TUALATIN ARCHITECTURAL REVIEW BOARD MEETING

TO: Architectural Review Board

SUBJECT:

Consideration of an Architectural Review application (AR21-0018) requesting approval of three buildings totaling 442,575 square feet located on a 21-acre site at 11345 SW Herman Road (2S122D000550). Building A will be 148,600 square feet, Building B will be 142,550 square feet and Building C will be 151,425 square feet.

PRELIMINARY SITE PLAN

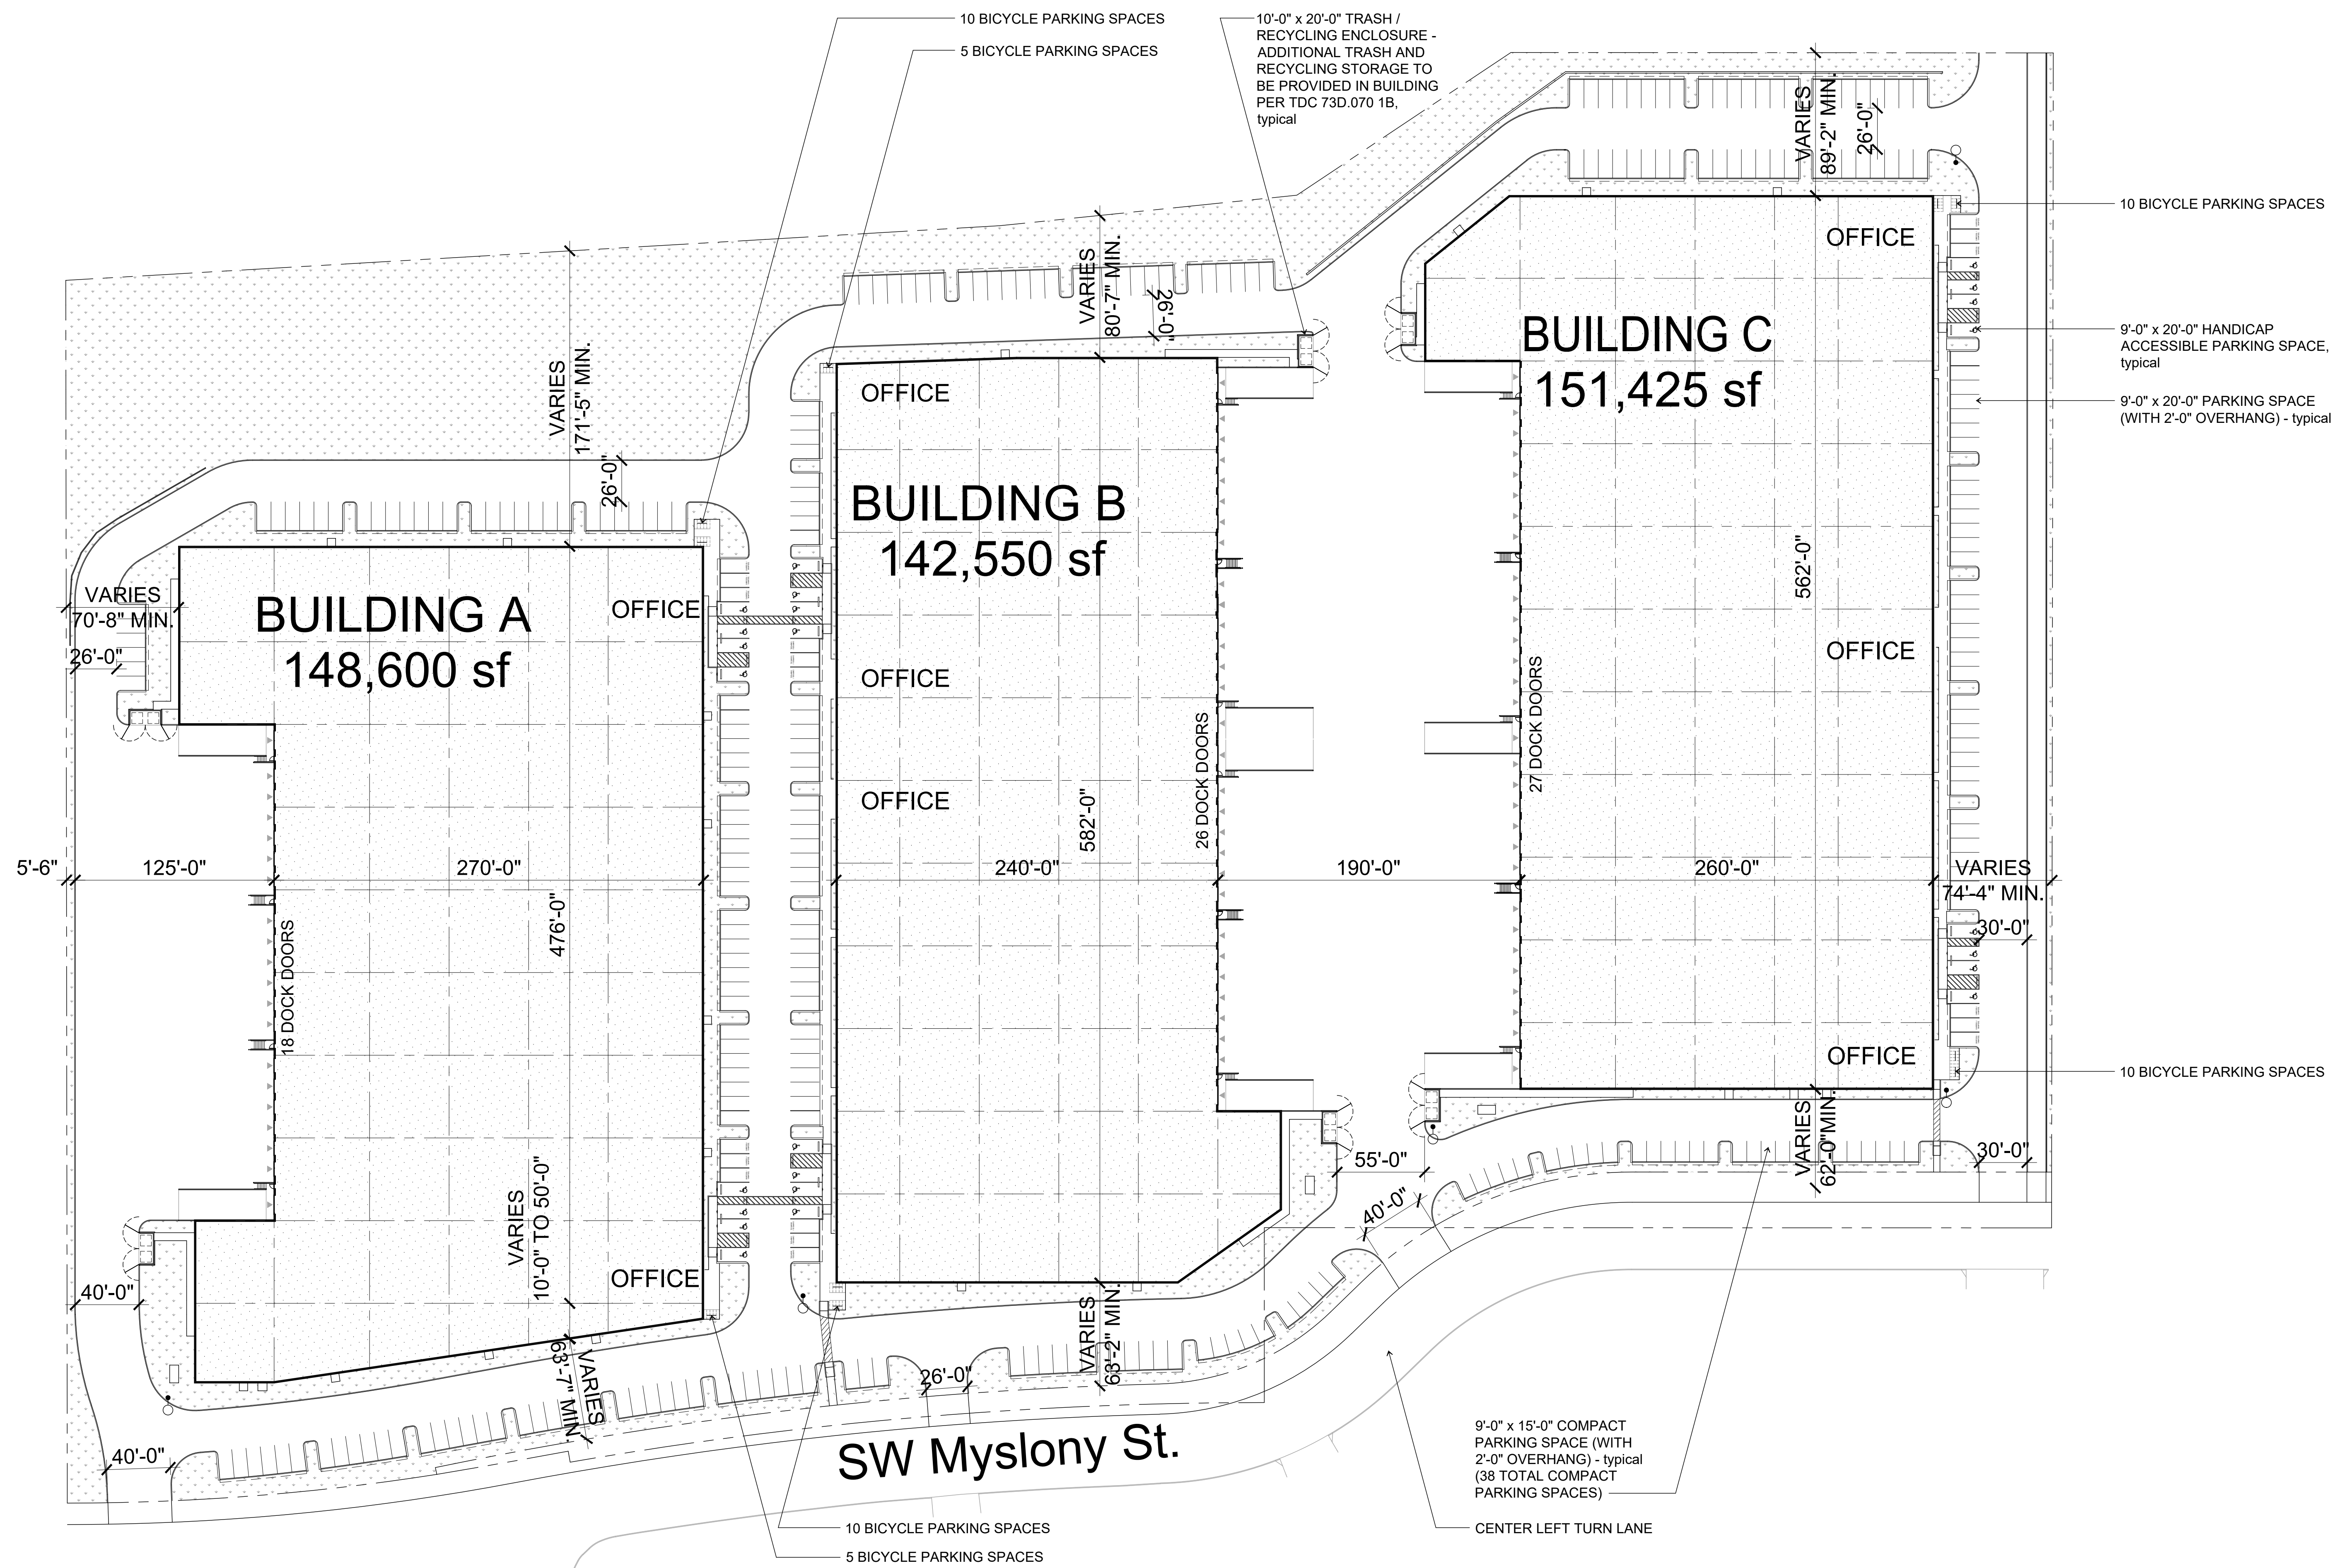
As shown on the Site Plan (Exhibit A2), 143,321 square feet or 15.67% of the total site area being landscaped. The Landscaping Plan (Exhibit A2) lists 147,915 square feet or 16.2% of the total land area being landscaped. Both plan sheets illustrate more landscaping proposed than the minimum landscaping 15% required by this section of the TDC. With the recommended Conditions of Approval A16, these standard are met.

Given that 335 parking spaces are proposed, 8,375 square feet of parking lot landscaping area is required. It’s unclear on the Site Plan or Landscape Plan (Exhibit A2) if the required parking lot landscaping area is met. Given 335 parking spaces, 84 trees are required and 86 are proposed (Exhibit A2). Curbs are included in the design and islands are provided at aisle ends. The landscape islands meet the spacing and size criteria as well. With recommended Condition of Approval A17.d., these standards are met.
